Re: Petition No. 1609 - TRITEC Americas, LLC notice of election to waive exclusion from Connecticut Siting Council jurisdiction, pursuant to Connecticut General Statutes §16-50k(e), and petition for a declaratory ruling, pursuant to Connecticut General Statutes §4-176 and §16-50k, for the proposed construction, maintenance and operation of a 0.999-megawatt AC solar photovoltaic electric generating facility located at 250 Carter Street, Manchester, Connecticut, and associated electrical interconnection. **Additional Pre-Filed Testimony – Part Three**

PRE-FILED TESTIMONY, PART THREE

**STORMWATER AND GROUNDWATER ISSUES BASED ON PETITIONER'S REVISED
STORMWATER MANAGEMENT REPORT FILED 4/23/2024.**

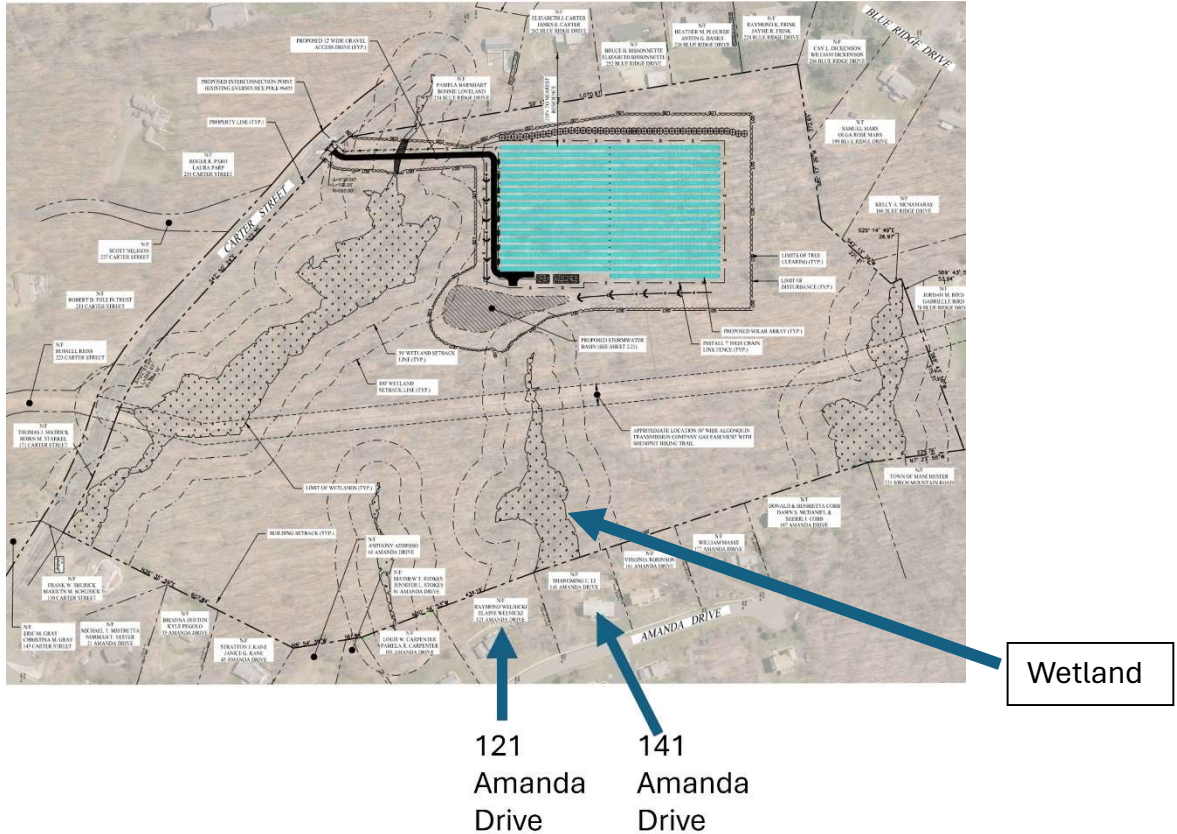
A. When this flooding threshold is reached, stormwater runoff begins to pond on certain surfaces on some of the properties along the east side of Amanda Drive, downslope of the proposed development. These properties include 101 Amanda Drive, 121 Amanda Drive,

141 Amanda Drive and 161 Amanda Drive. As the intensity and duration of the rain event and the amount of precipitation increases, the flooding progresses to a larger area of ponding. At some locations (e.g., 121 Amanda Drive and 161 Amanda Drive), larger storms cause the ponding to spill over onto the sidewalk and then over the curb and onto Amanda Drive itself.

A. I will restrict my answer to the properties that I have been able to observe directly during rainstorms: 121 Amanda Drive and 141 Amanda Drive. Based on these direct observations, it is apparent to me that the stormwater runoff onto these two properties is sourced primarily from the wetlands directly upslope of those properties. This wetland is shown on the map below which is taken from the Stormwater Management Report filed with the Petition on January 24, 2024 (my notations added).

From those observations and the map below, I conclude that the stormwater runoff is sourced primarily from the wetlands.

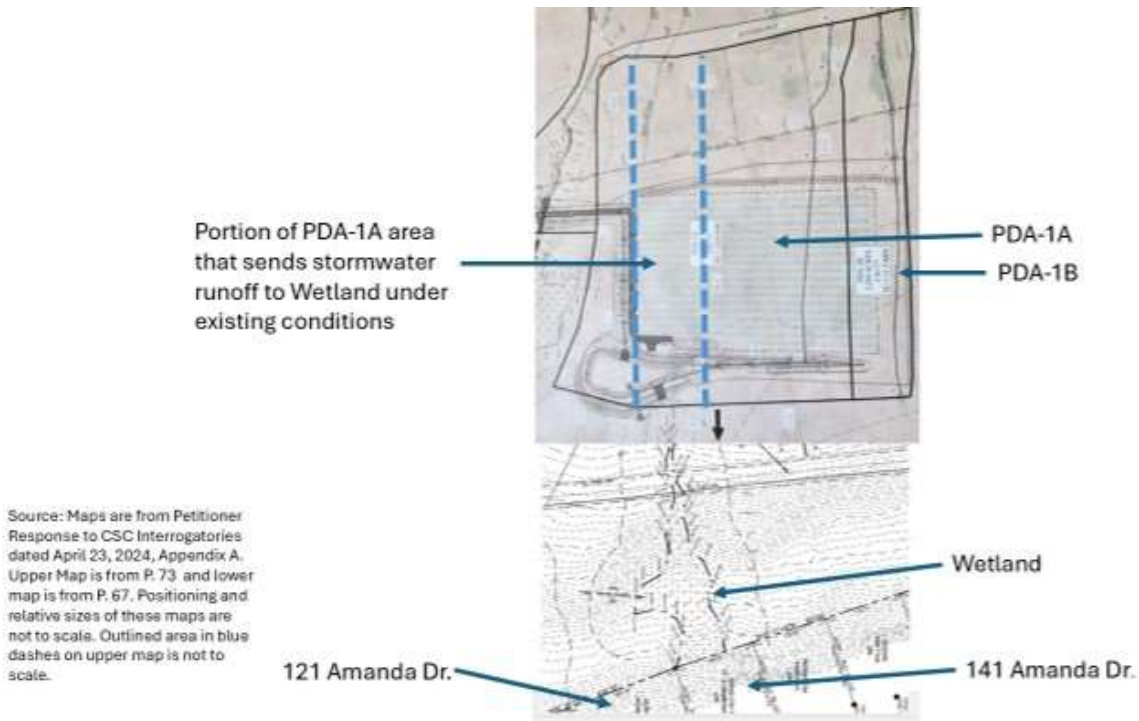
A. The Revised Stormwater Management Report submitted by the Petitioner on April 23 would divert stormwater runoff from a 10.448-acre drainage area to a stormwater basin and from there in the direction of the wetland immediately downslope of the proposed development. This is the wetland depicted earlier that lies upslope of 121 Amanda Drive and 141 Amanda Drive. I believe that the amount of stormwater runoff directed into that wetland under this proposal would be a multiple of the amount of stormwater runoff that currently reaches that wetland. This will send a much greater flow of stormwater than under existing conditions downslope and onto 121 Amanda Drive and 141 Amanda Drive.

A. Very simply put, the proposed stormwater management plan would increase the effective size of the drainage field flowing into the wetlands compared to existing conditions. Consider:

1. The drainage area for the proposed stormwater basin is labeled PDA-1A in the stormwater management plan.
2. That drainage area is 10.448 acres. While not a perfect rectangle, scale measurements that I took from the mapped site exhibits suggest that the drainage area PDA-1A is approximately 588 feet from north to south and approximately 773 feet from east to west. (Note that a rectangle of 588 feet by 773 feet would equal 10.434 acres which is almost identical to the actual PDA-1A area of 10.448 acres.)
3. The widest north-south width of the wetlands in question appears to be between 170 and 190 feet. For conservatism, let's use 190 feet.
4. Under existing conditions, the portion of the area PDA-1A that could be said to send stormwater runoff to the wetland is a rectangle running the same east-west distance as

PDA-1A and running approximately 190 feet north to south – i.e., the approximate north south width of the wetland in question.

5. So one could reasonably assume that the existing conditions “drainage area” within the PDA-1A area for the wetland is approximately a 190-foot-wide slice (running north-south) of the PDA-1A area. This is represented on the following diagram (NOTE: this is a representation and is not drawn precisely to scale):

6. Since the approximate north-south width of PDA -1A is 588 feet, the existing conditions stormwater runoff area for the wetland is approximately $190 \div 588$ or 32% of the drainage area PDA-1A. This means that the existing conditions drainage area within PDA-1A for the wetland in question is approximately 32% of 10.448 acres, or approximately 3.34 acres.

7. Accordingly, it appears that the PDA-1A drainage area is approximately 3.13 times larger than the wetland’s existing conditions drainage area within the PDA-1A area. Thus, unless there are other factors to consider, one could assume that the proposed development

10. Therefore, I believe it is likely that the proposed development will generally triple the amount of stormwater runoff to the wetland in question during and shortly after large storms. That runoff would then flow towards and onto the properties at 121 and 141 Amanda Drive.
